RE: BEHS PSC - BG 25-145 - Change Order 15 - Ductwork Revisions

Change Order

Change Order Request 20 - PCO #55 - RFP-11 Ductwork Revisions Version 2

REQUEST FOR PROPOSAL

2023-50.1
WALL CHANGES
M2.02
BEHS

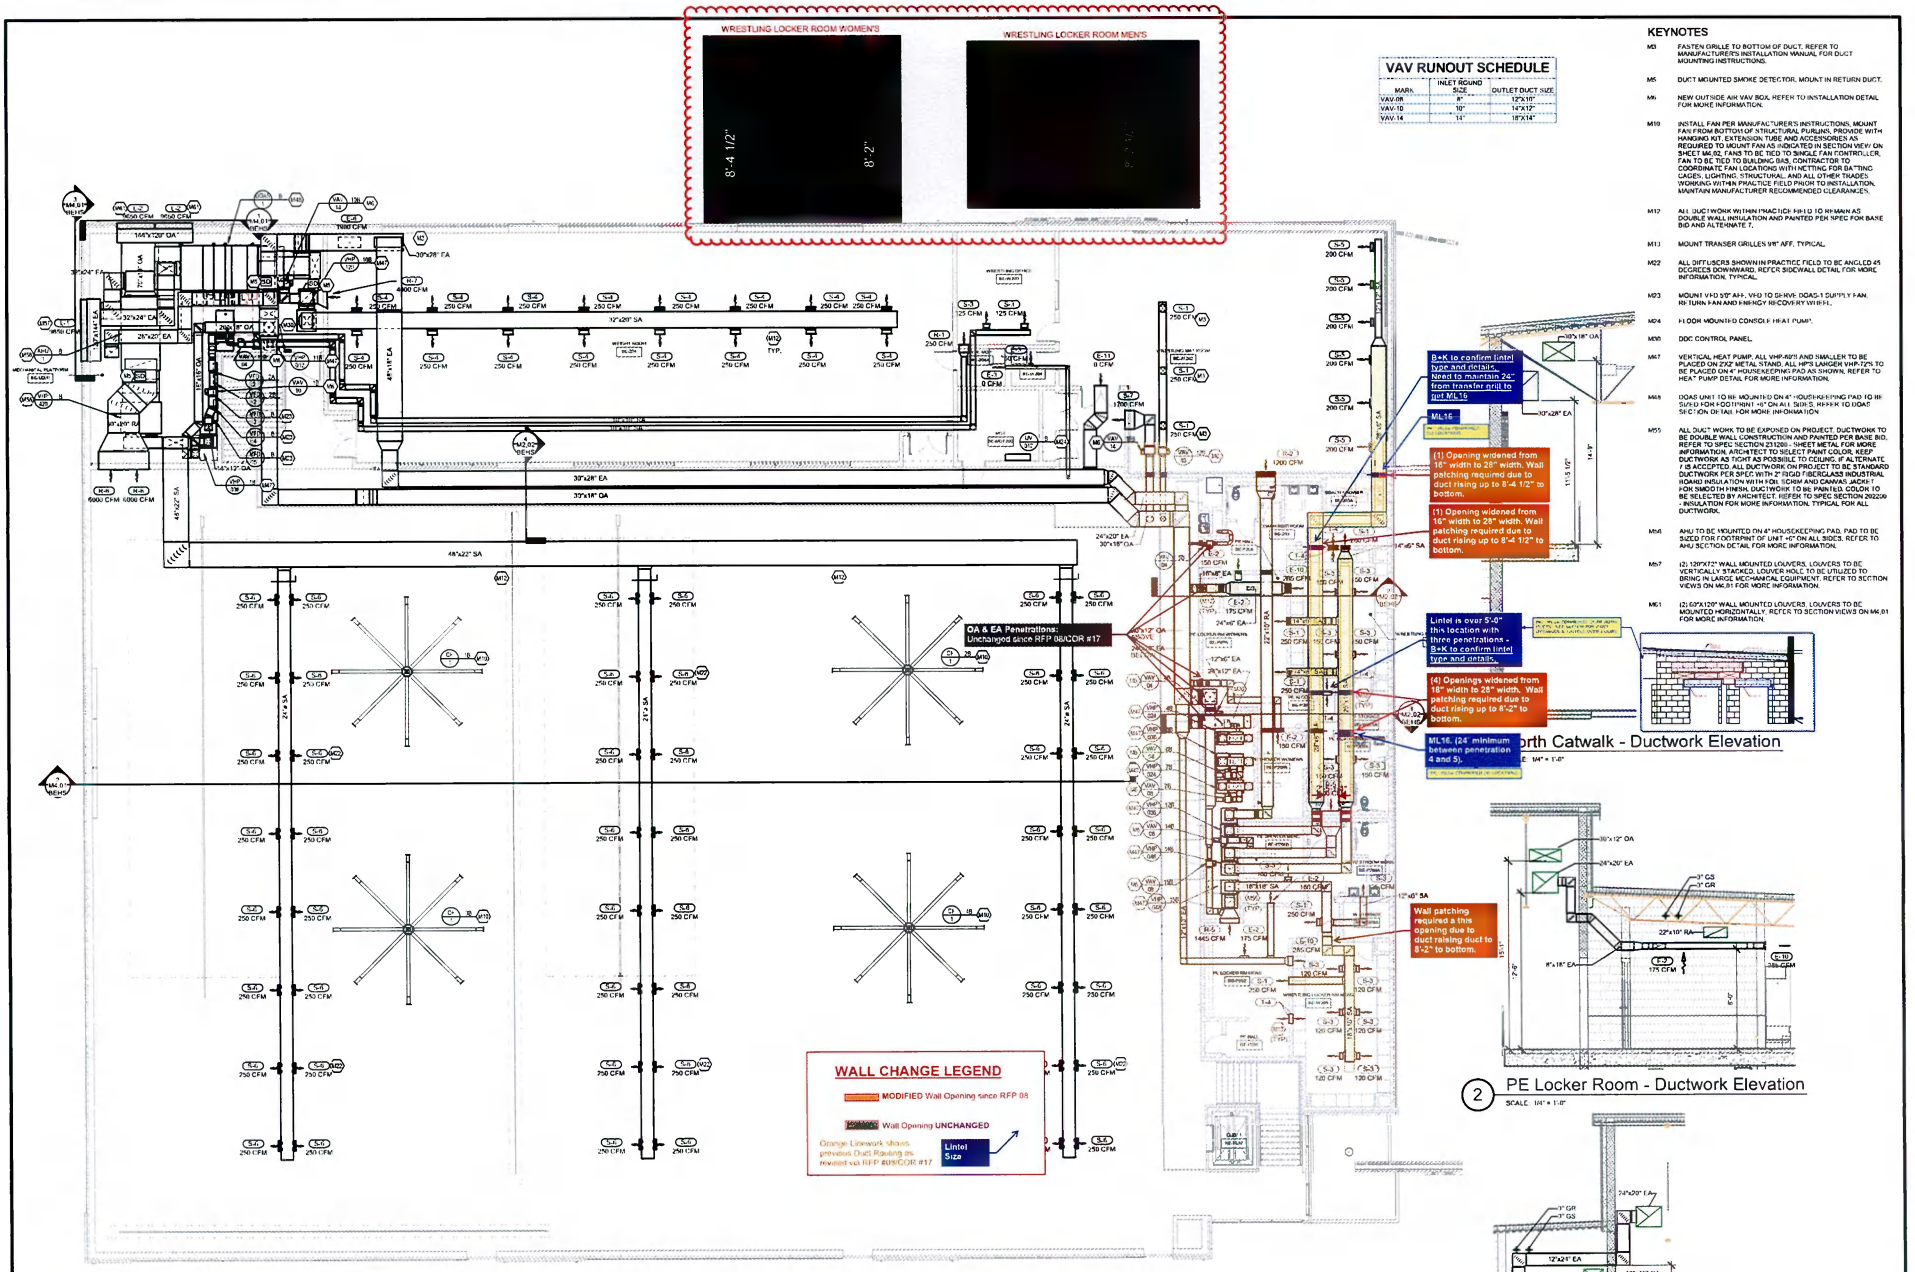
Item No.1 Wall Penetration Plan (Mark-Ups to M2.02)

- See Mark-Ups on M2.02 showing masonry wall penetration revisions after RFP 08/COR #17 is considered.

2023-50.1
DUCT CHANGES
M2.02
BEHS

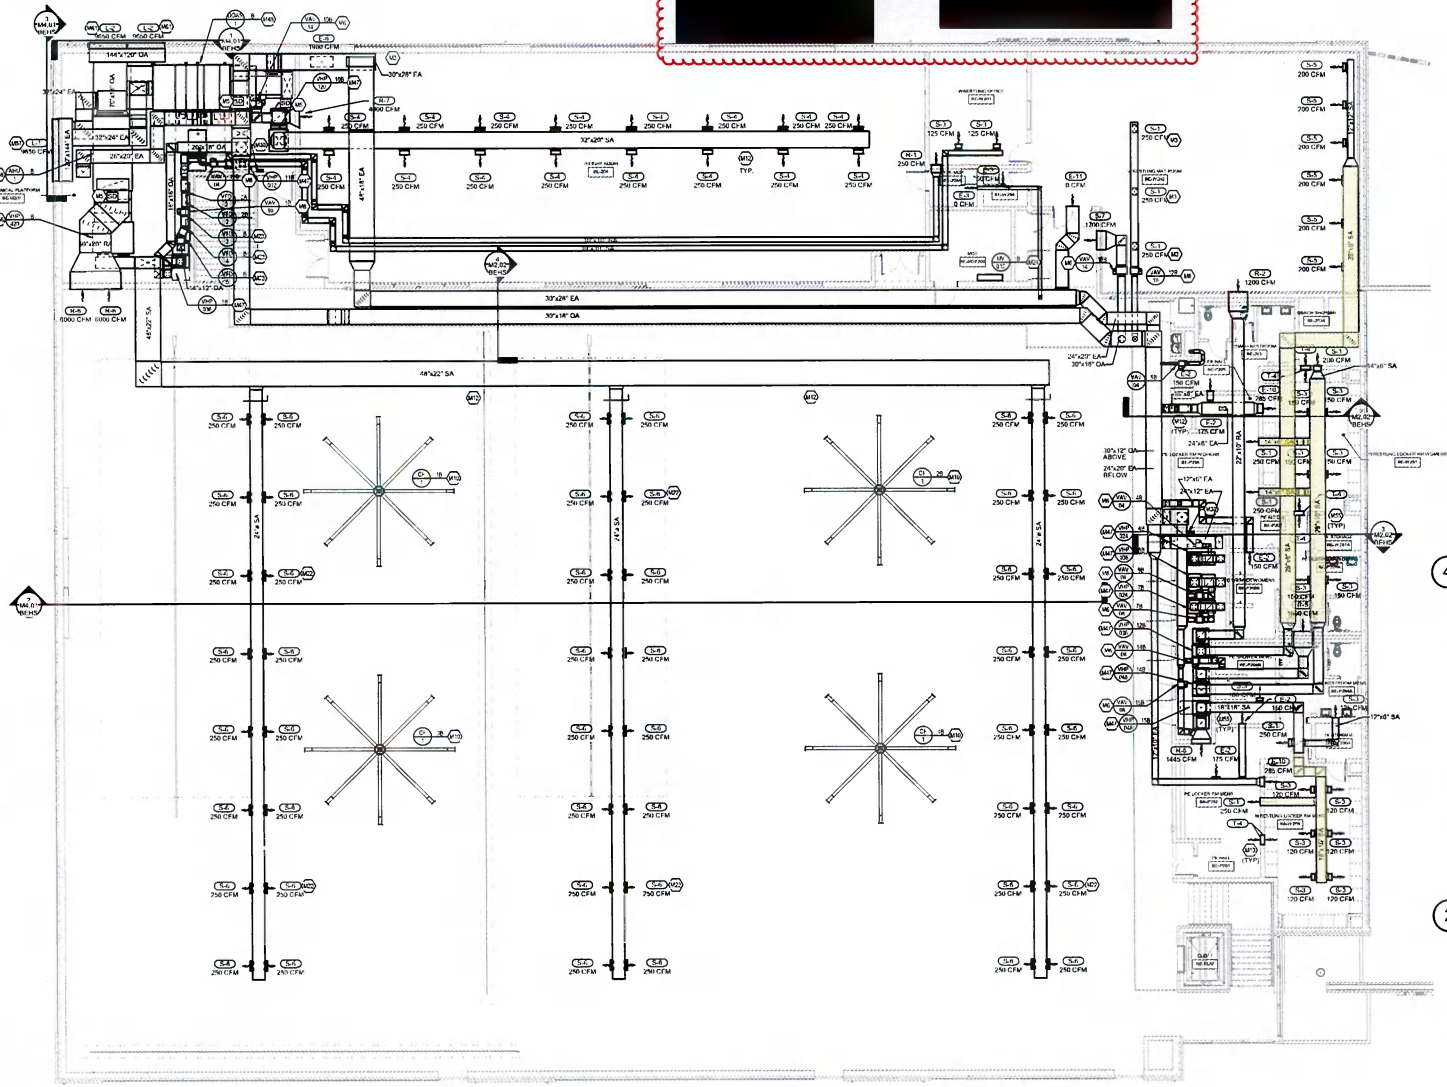
Item No.2 M2.02

- See Clouded Areas for Ductwork revisions at 2nd Level Locker Room Areas after RFP 08/COR #17 is considered.
- Affected ducts are highlighted in Yellow.

E1.22
BEHS

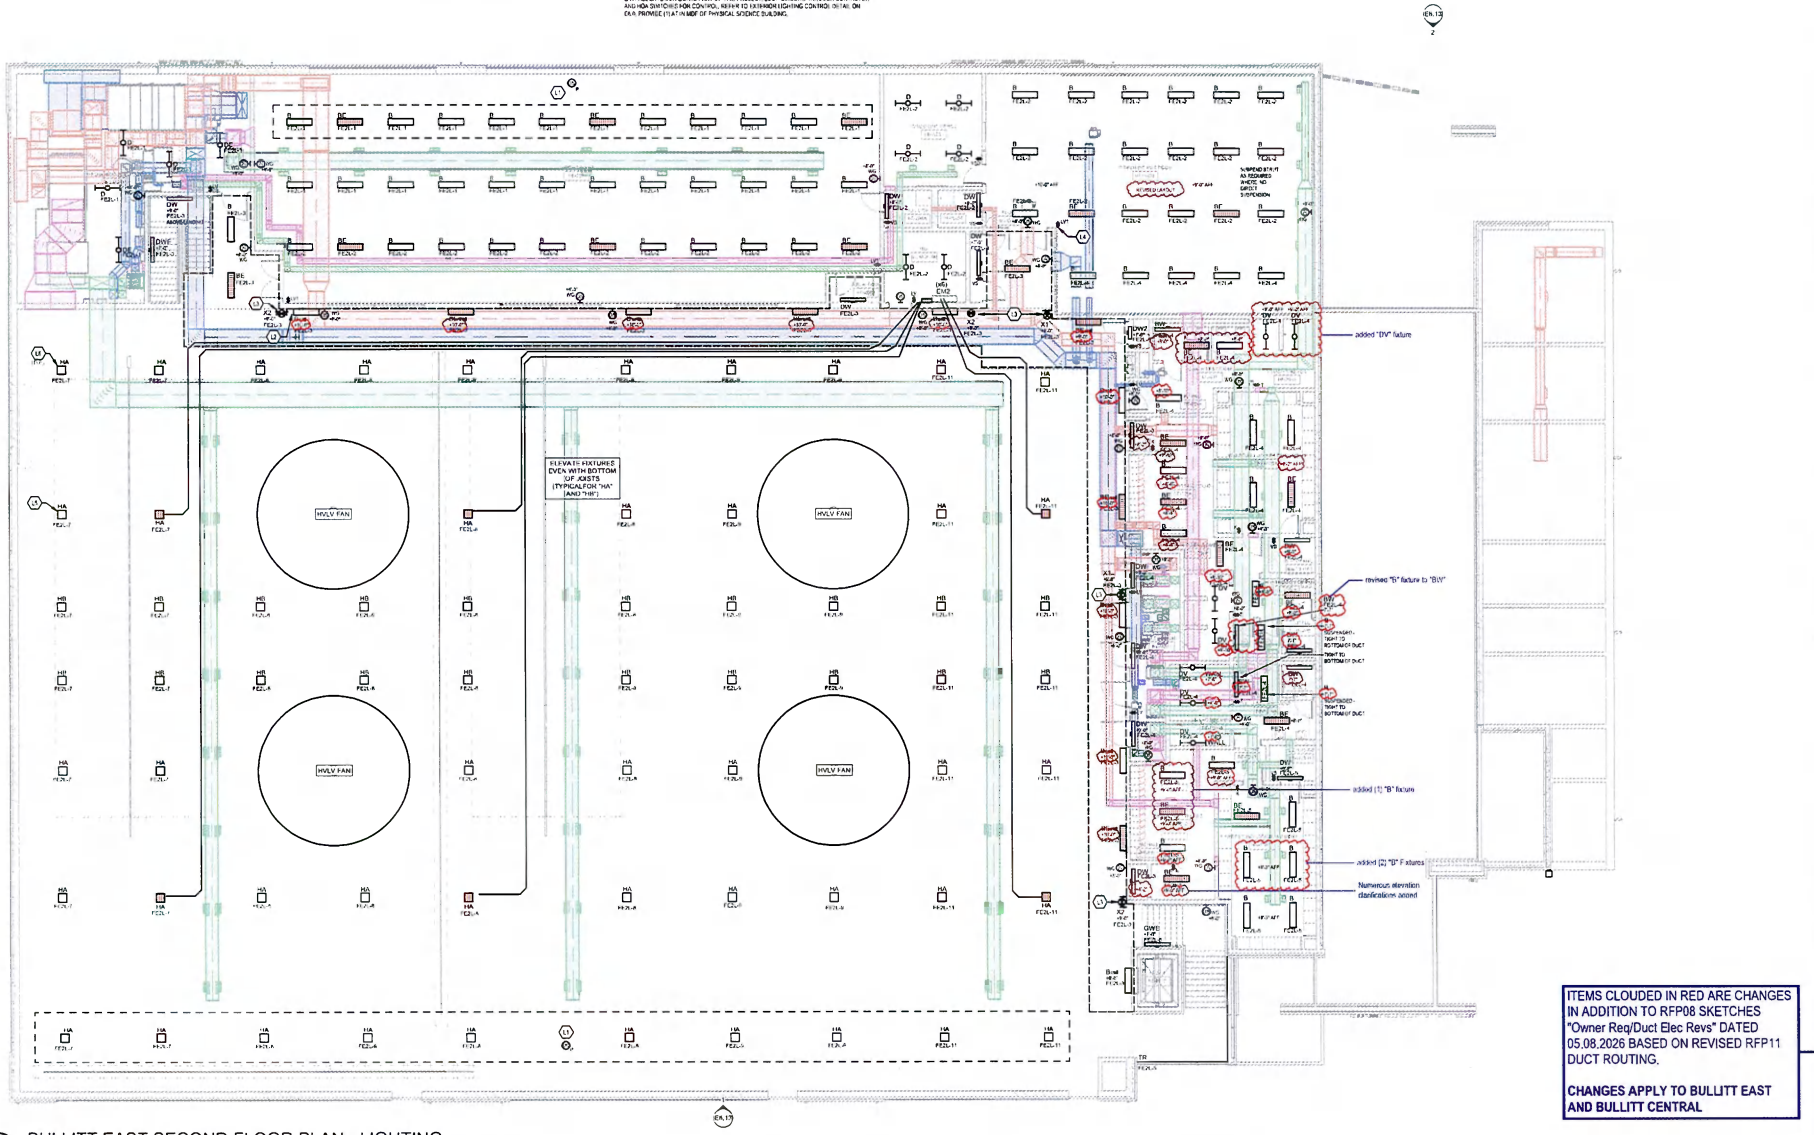
ITEMS CLOUDED IN RED ARE CHANGES IN ADDITION TO RFP08 SKETCHES "Owner Req/Duct Elec Revs" DATED 05.08.2026 BASED ON REVISED RFP11 DUCT ROUTING.

CHANGES APPLY TO BULLITT EAST AND BULLITT CENTRAL

M2.02
BEHS

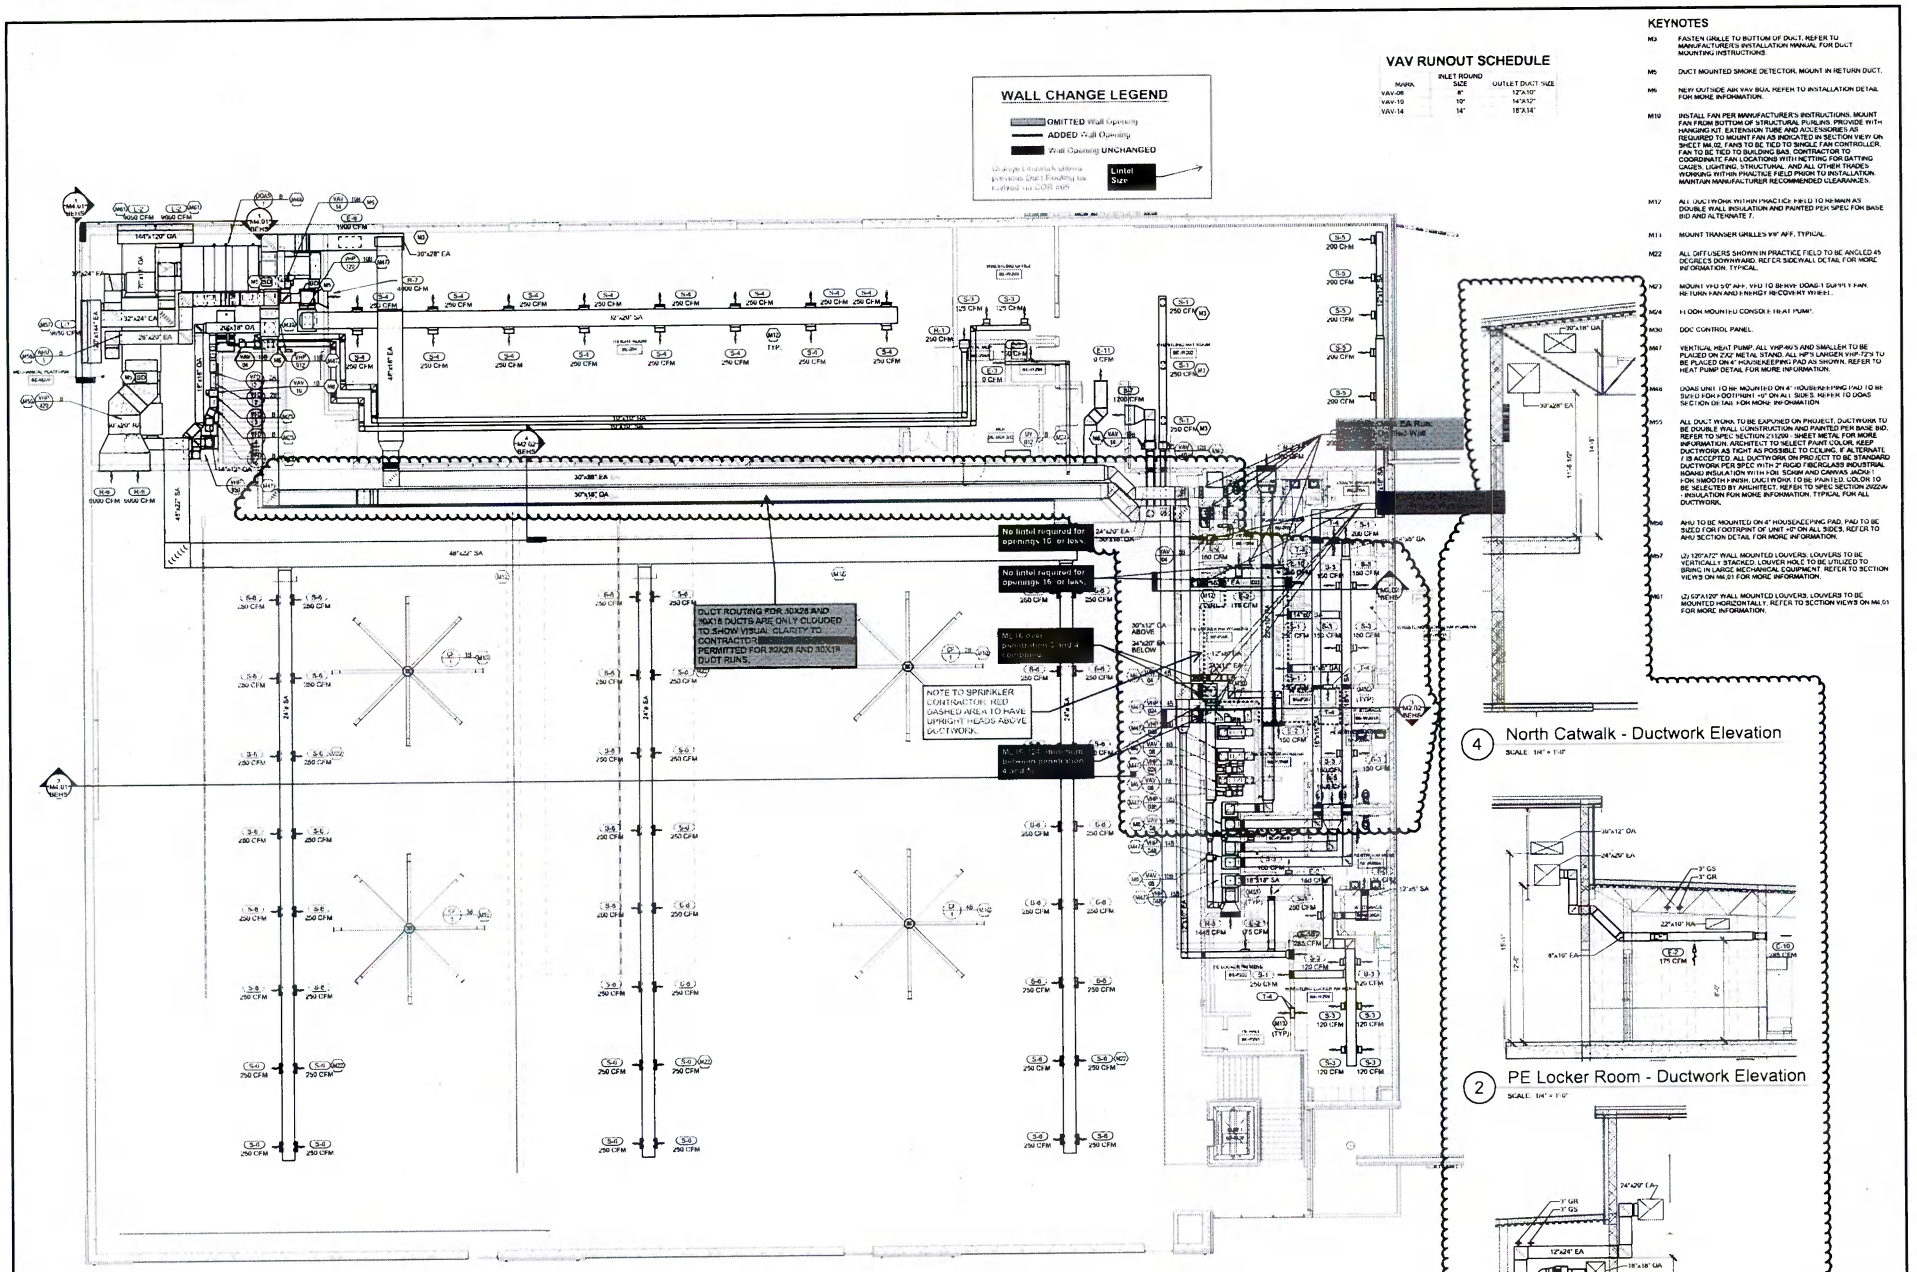
Item No.2 M2.02

- See Clouded Areas for Ductwork revisions at 2nd Level Locker Room Areas.
- Area for Fire Protection Revisions noted with Dashed Line.

REVISED DRAWING - SIZES HIGHLIGHTED

- DENOTES MODIFIED DUCTWORK WALL PENETRATION

DUCT ROUTING FOR 30X26 AND 30X35 DUCTS ARE ONLY CLOUDED TO SHOW VISUAL CLARITY TO CONTRACTOR. NO COST CHANGE IS PERMITTED FOR 30X26 AND 30X16 DUCT RUN.

NOTE TO SPRINKLER CONTRACTOR: RED DASHED AREA TO HAVE UPRIGHT HEADS ABOVE DUCTWORK.

M2.02
BEHS

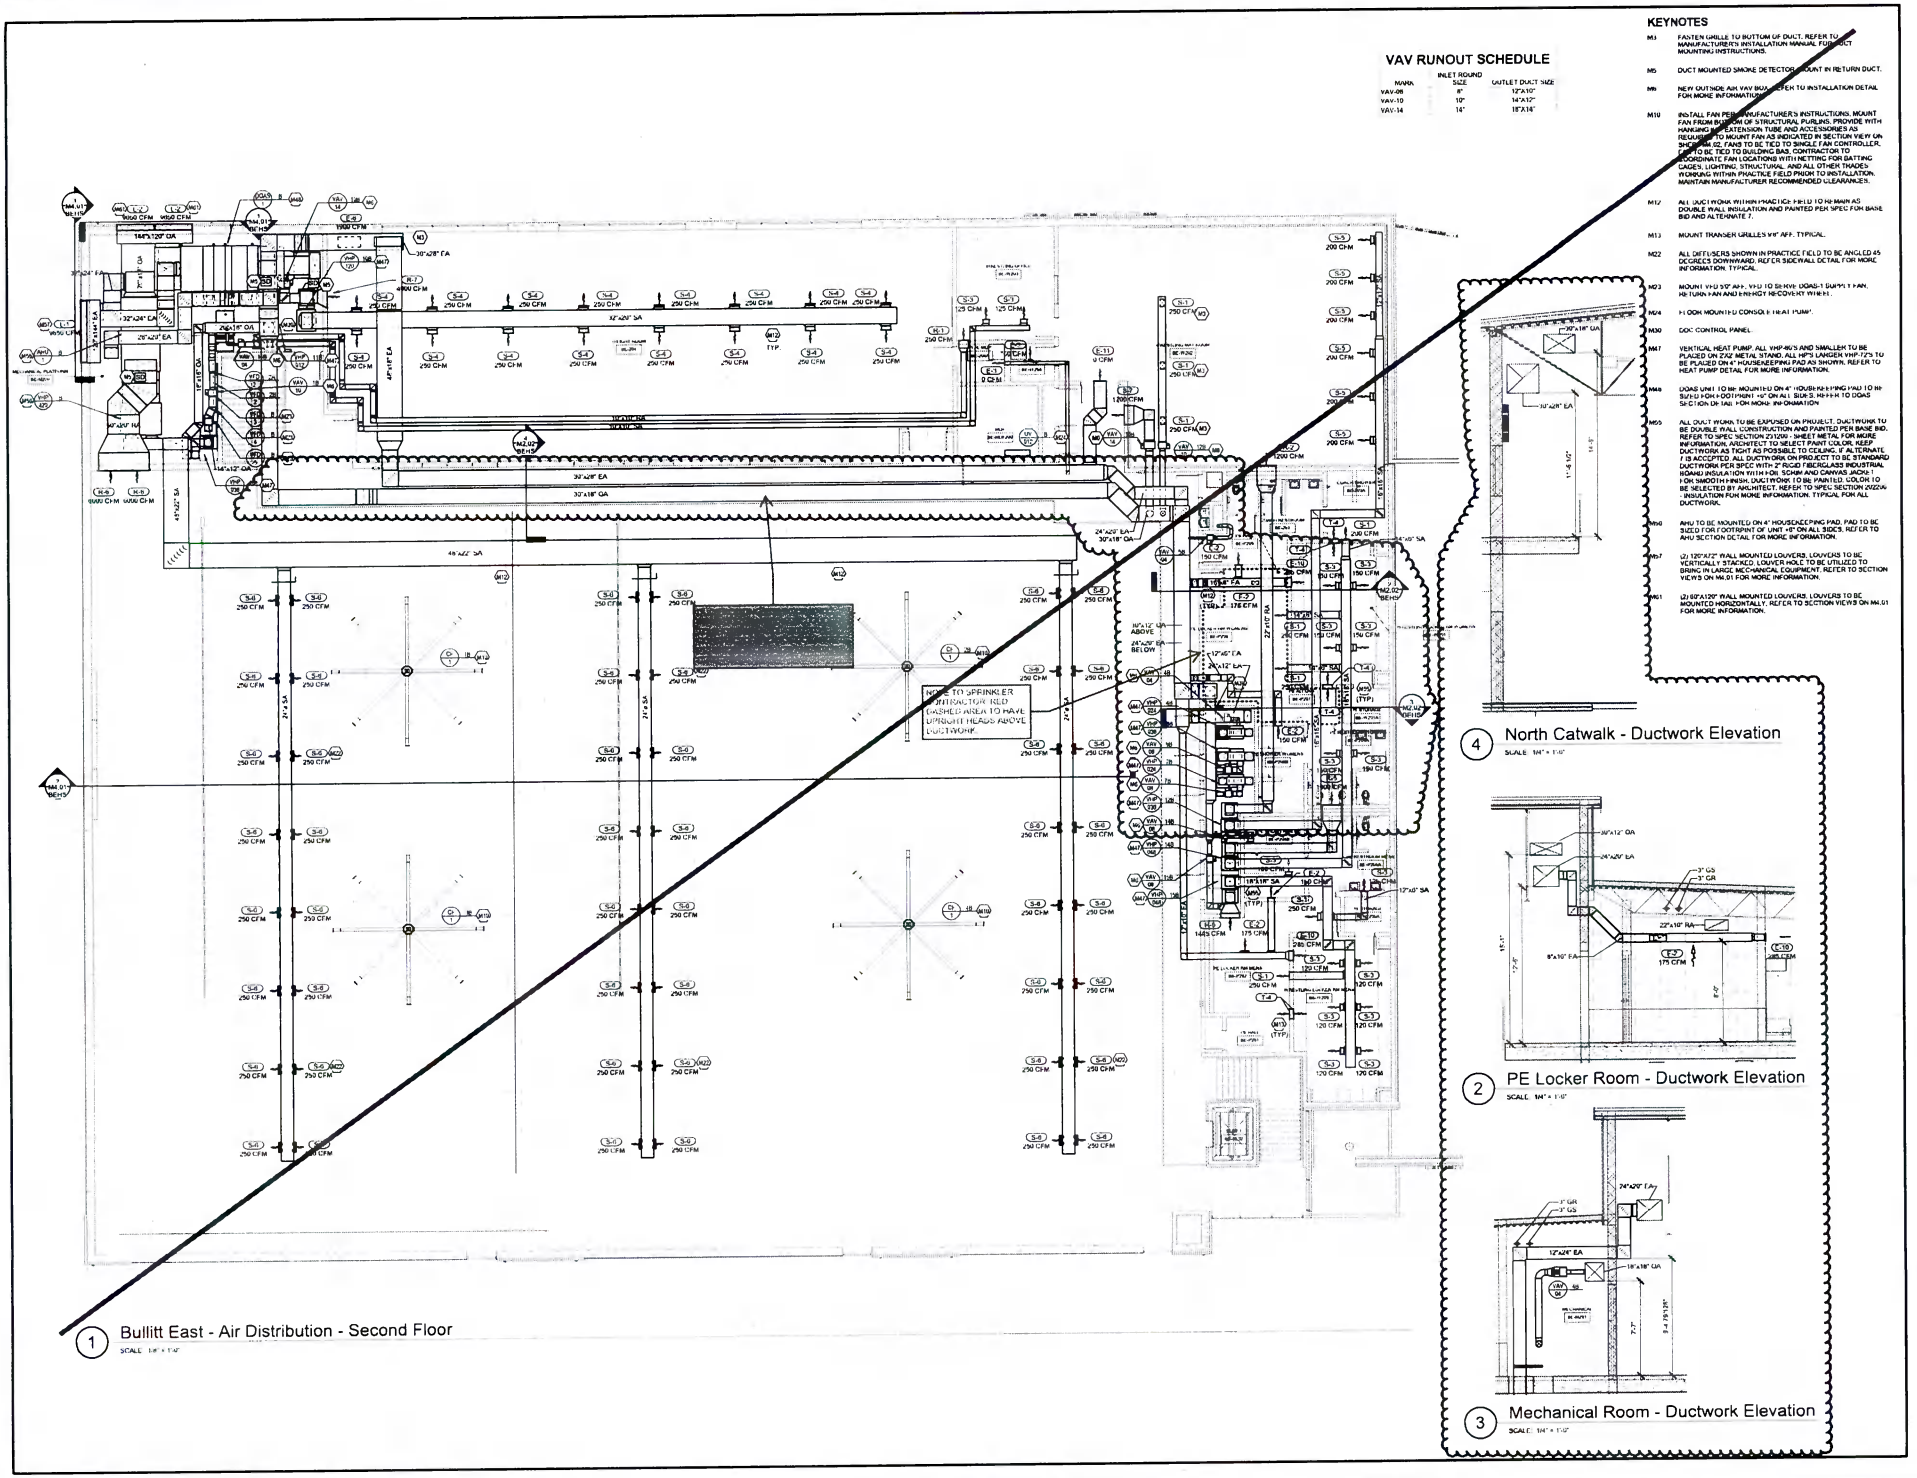
Item No.1 Wall Penetration Plan (Mark-Ups to M2.02)

- See Mark-Ups on M2.02 showing masonry wall penetration revisions.
